Southern Nuclear Operating Company
Vogtle Electric Generating Plant Units 3 and 4 Combined License Application
Response to Request for Additional Information Letter No. 044

Enclosure: Response to NRC RAI Letter No. 044 on the VEGP Units 3 & 4 COL
Application Involving the Offsite Electrical Power System

FSAR Section 8.2, Offsite Power System

NRC RAI Number 08.02-13:

Figure 1
Analysis of Overhead Transmission Line Crossings

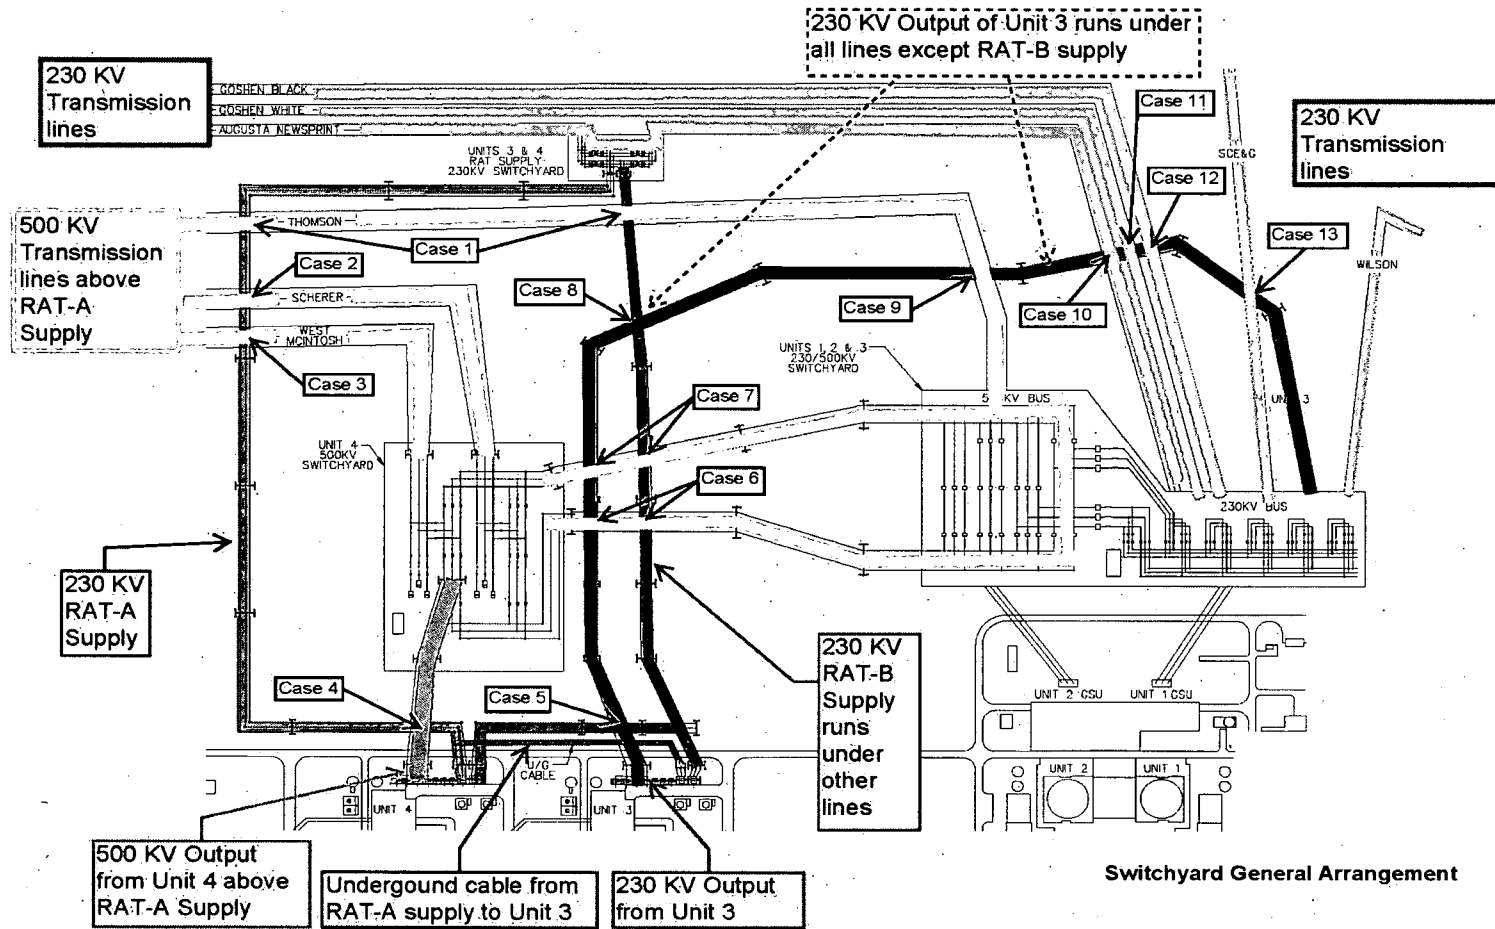
Regulatory Guide 1.206, "Combined License Applications for Nuclear Power Plants (LWR Edition)," recommends that the FSAR description of offsite power should include all unusual features of the transmission lines such as crossovers or proximity of other lines (to ensure that no single event such as a tower falling or a line breaking can affect availability of offsite power to Units 3 and 4). Figure 8.2-202 of the VEGP FSAR shows several line crossings. The NRC staff is concerned that during adverse weather conditions high winds could cause the loss of both the 500 kV and 230 kV lines to supply offsite power to Units 3 and 4. Perform an analysis of each crossing of lines and demonstrate that this vulnerability is acceptable for Vogtle offsite power system design for Units 3 and 4.

An analysis was performed of transmission line crossings within the area of the Vogtle site. Sixteen line crossing locations were evaluated to demonstrate that offsite power would be available to both Unit 3 and Unit 4 from at least one of the three available offsite power supplies to each unit and to confirm that Units 1 and 2 would not be affected. A nonmechanistic failure was assumed for each of the 16 transmission lines (a line is considered to be any one of the three phases) allowing it to fall on the line or lines immediately below it, resulting in a fault on each of the associated lines. In three cases, the falling line was assumed to contact two lines below. In all, 13 separate cases of falling transmission lines were evaluated. No single failures of protective relaying or breakers were assumed in this evaluation.

The evaluation demonstrated that, in each case, at least one offsite power supply remained available to both Unit 3 and Unit 4. In addition, there were no adverse effects to Unit 1 or Unit 2. The following attachments are provided as supporting information for this response. Figure 1 shows the layout of the Vogtle switchyards and associated transmission network along with the cases studied. The overhead line for each crossing is shown as the unbroken line. Table 1 summarizes the results of the evaluation. The information shown in the Application Revision section below will be incorporated into a future application revision.
